SAN ANTONIO WATER SYSTEM
ANDERSON PUMP STATION IMPROVEMENTS
SAWS JOB NO. 07-6007
SOLICITATION NO. B-11-002-DD

ADDENDUM NO. 1
April 21, 2011

E-6
SHEET
41 OF 102

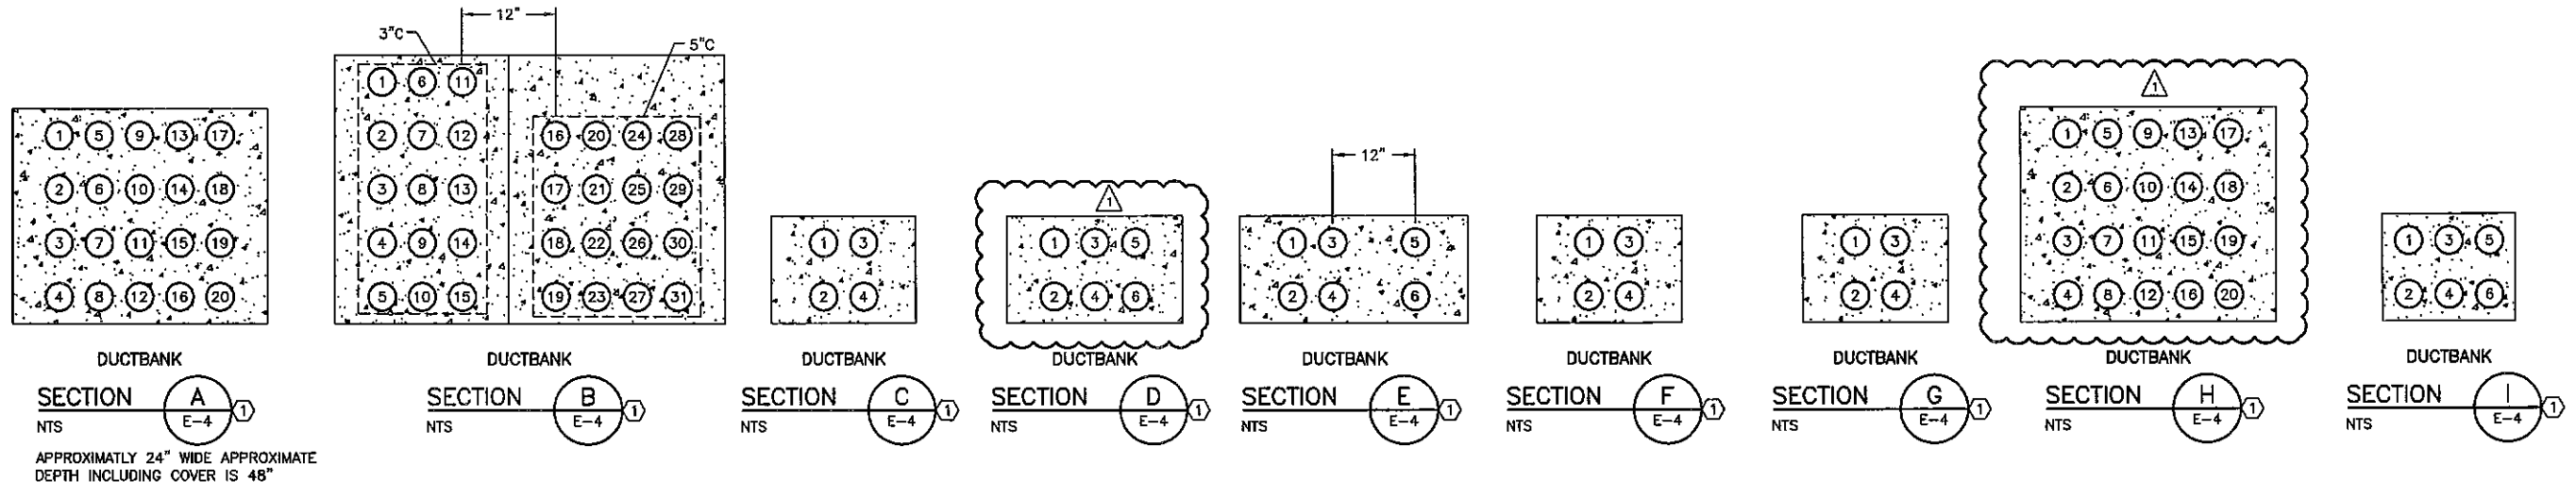
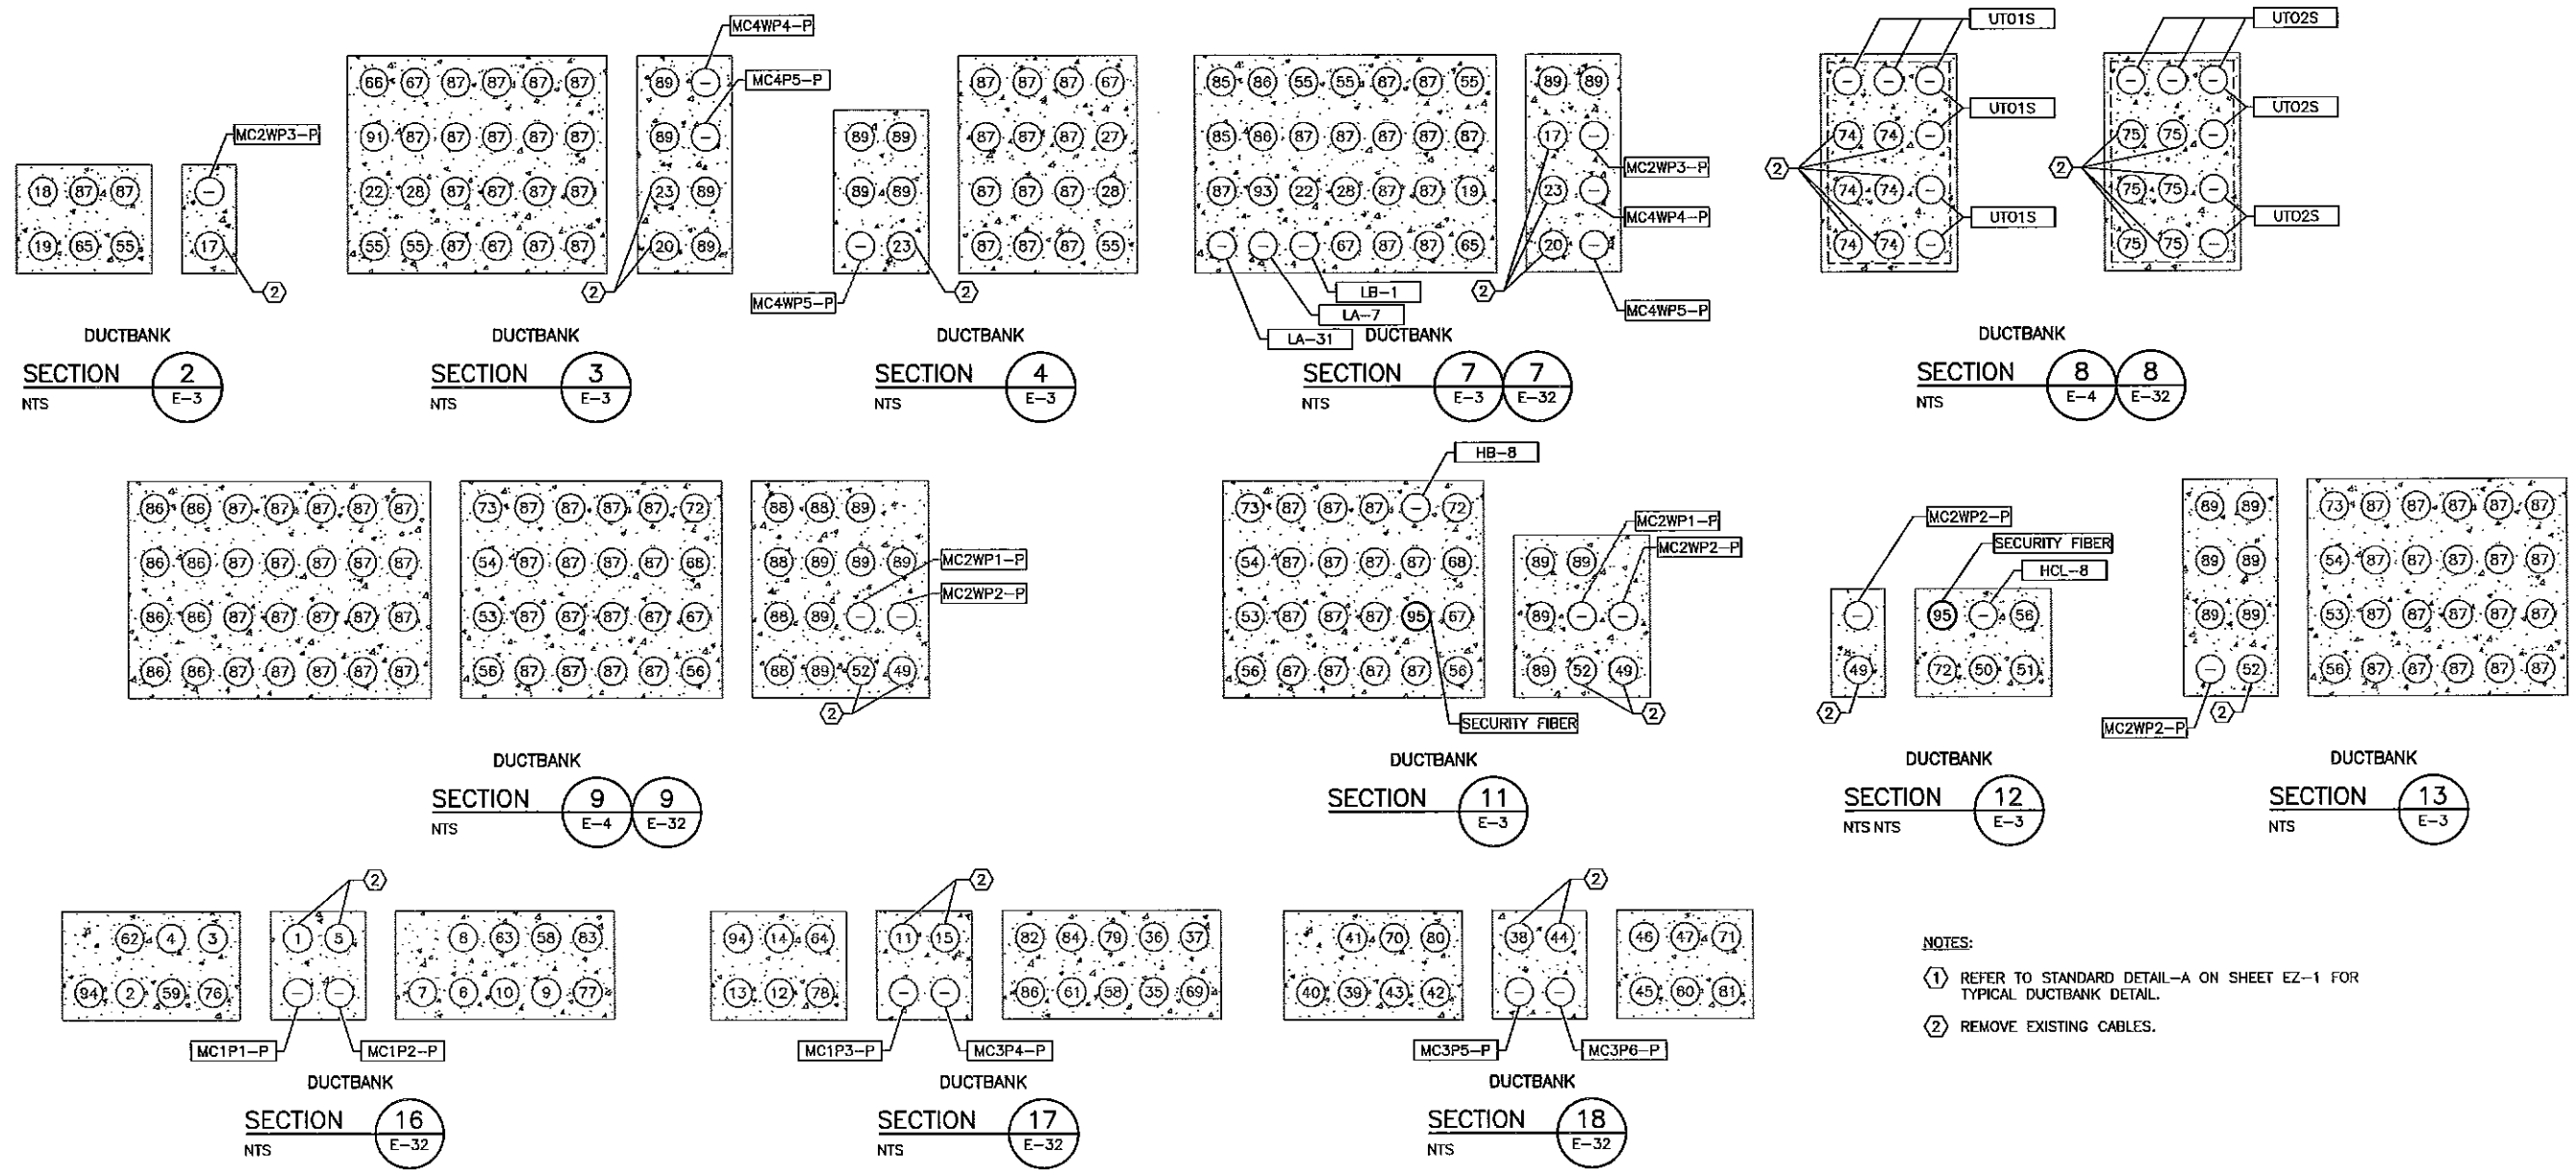
3. Sheet D2 (21 of 102).
 - a. On the Pressure Sustaining Valve Station Plan, change the 5'-1" dimension to 7'-1" and change the 14'-7" dimension to 12'-7".
4. Sheet E5 (40 of 102).
 - a. Replace Sheet E5 with new Sheet E5 that is included with this Addendum No. 1. Changes are shown in the clouded areas.
5. Sheet E6 (41 of 102).
 - a. Replace Sheet E6 with new Sheet E6 that is included with this Addendum No. 1. Changes are shown in the clouded areas.
6. Sheet E7 (42 of 102).
 - a. Replace Sheet E7 with new Sheet E7 that is included with this Addendum No. 1. Changes are shown in the clouded areas.
7. Sheet I2 (90 of 102).
 - a. Replace Sheet I2 with new Sheet I2 that is included with this Addendum No. 1. Changes are shown in the clouded areas.

I-2
 SHEET
 90 OF 102

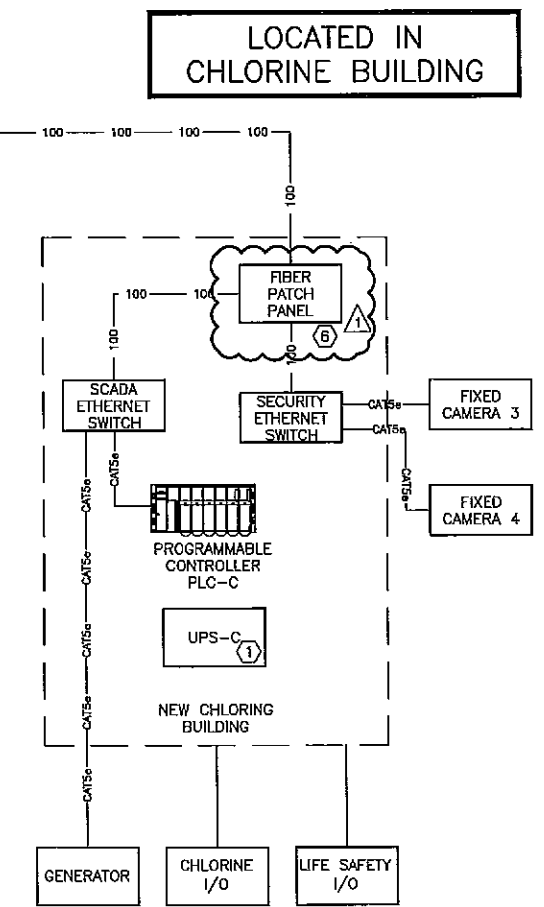
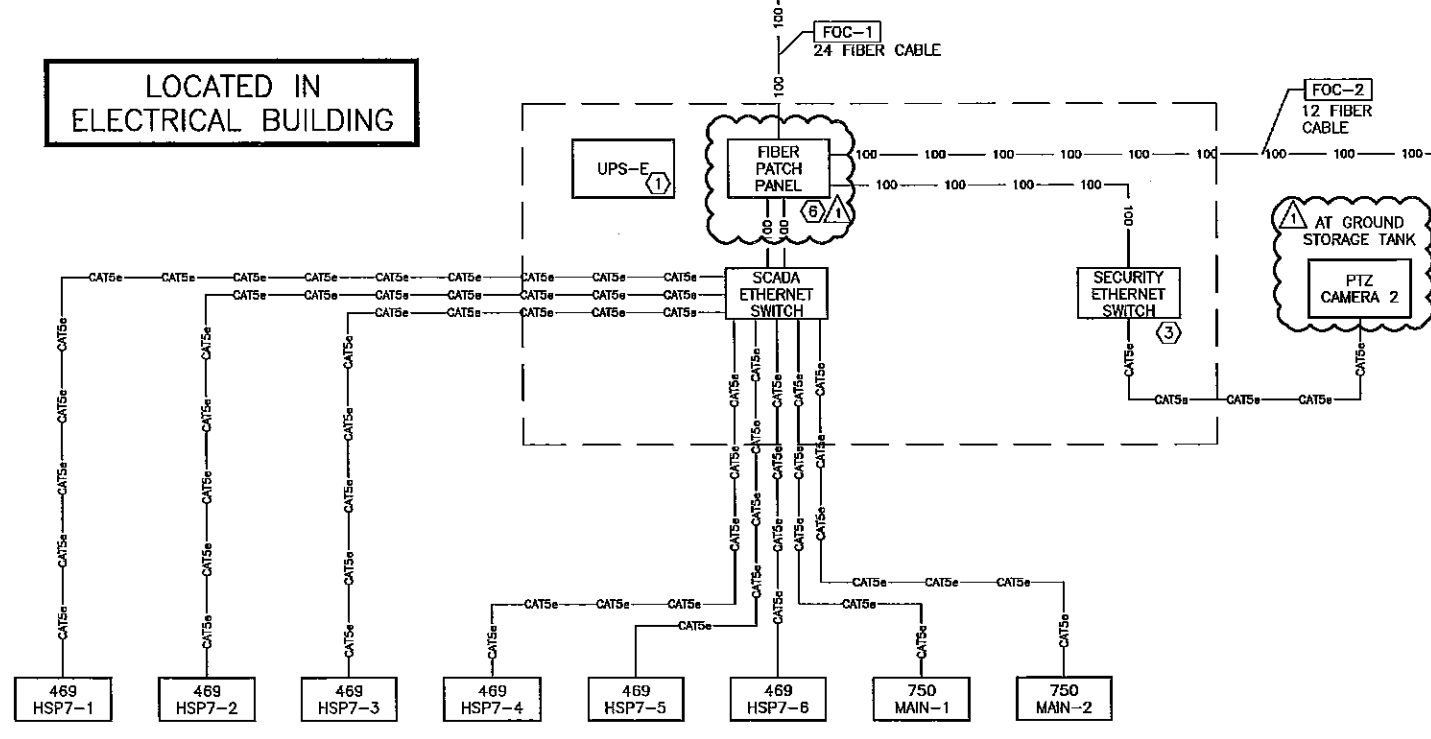
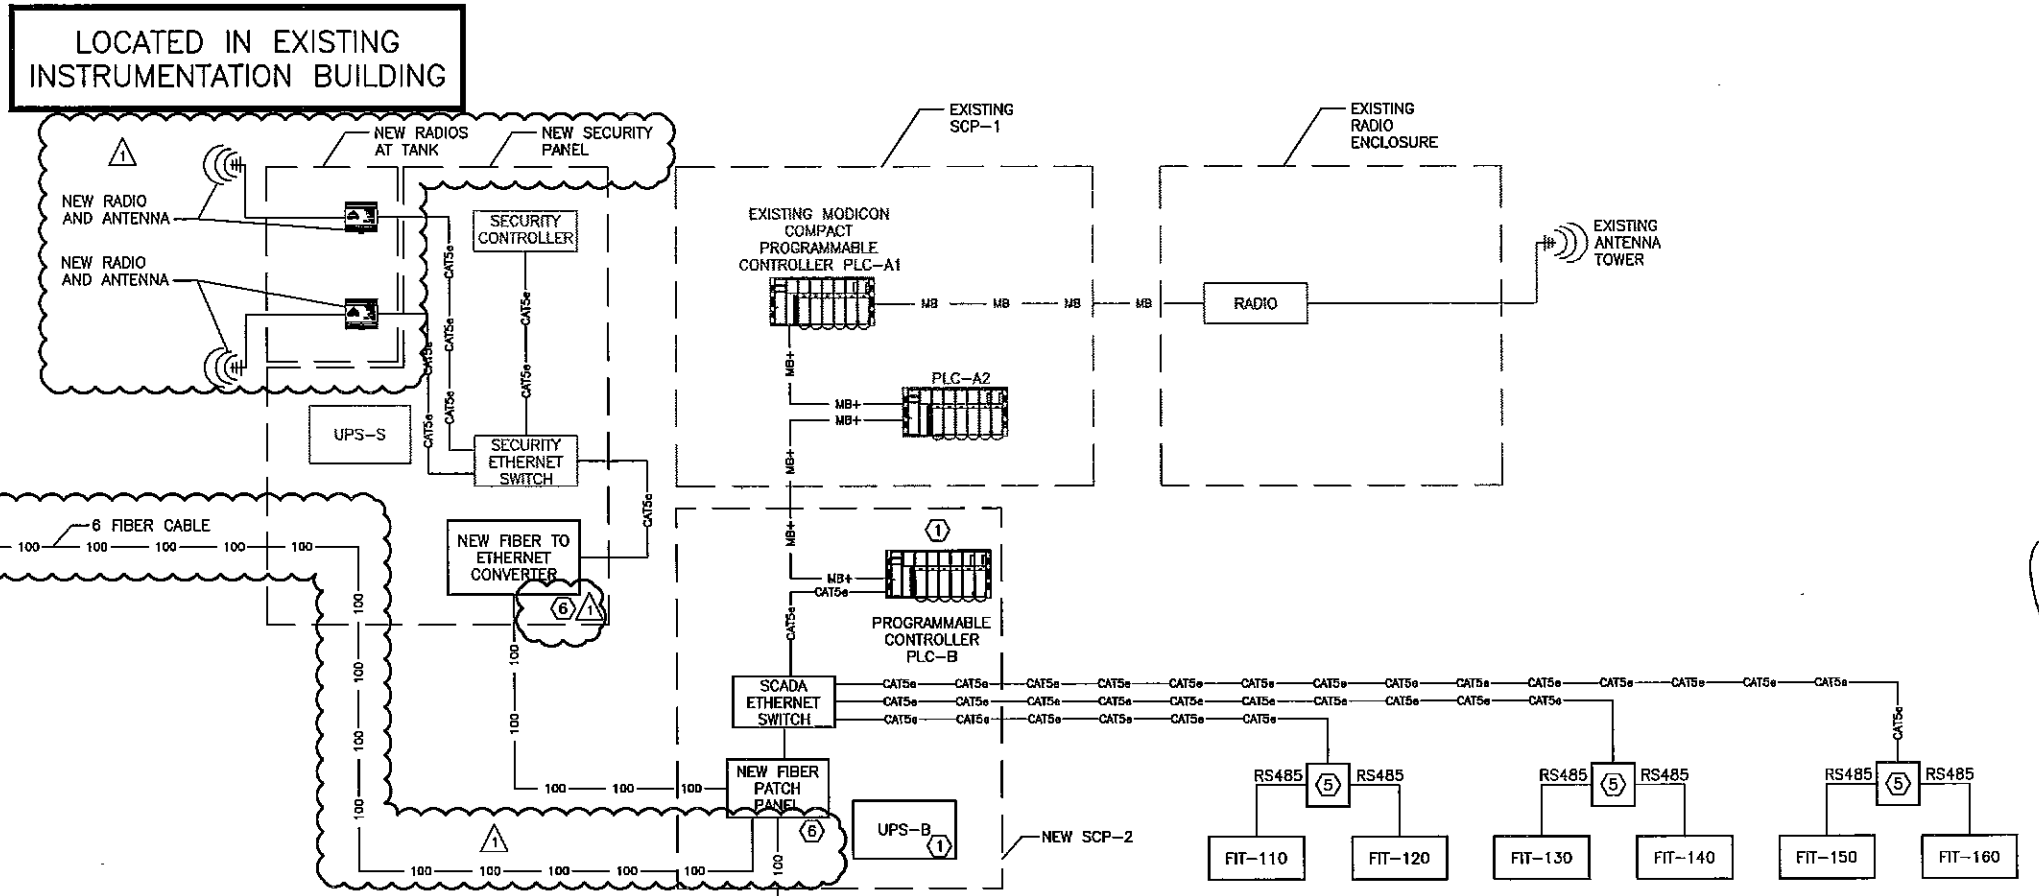
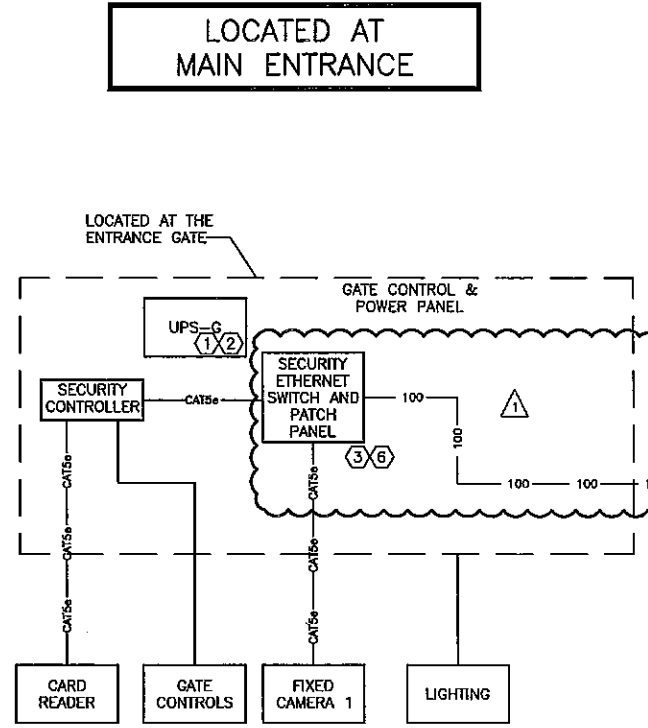
when the “valve closed” is initiated. Sheet I-9 P&ID shows a low battery and failure output for each of two control panels. This drawing also shows valve-opened and valve-closed outputs for each actuator. These capabilities are not described in Section 11725, Article 2-3.05, but have been provided on most of SAWS previous jobs. RESPONSE: We do want the “valve close” output contact and the valves should be provided with the signals shown on the P&ID. See changes to Section 11725 included with this addendum.

"As indicated on the P&ID drawings, each control panel shall also provide a contact to indicate that the valve is open, a contact to indicate that the battery is low, and a contact to indicate that the valve has failed."
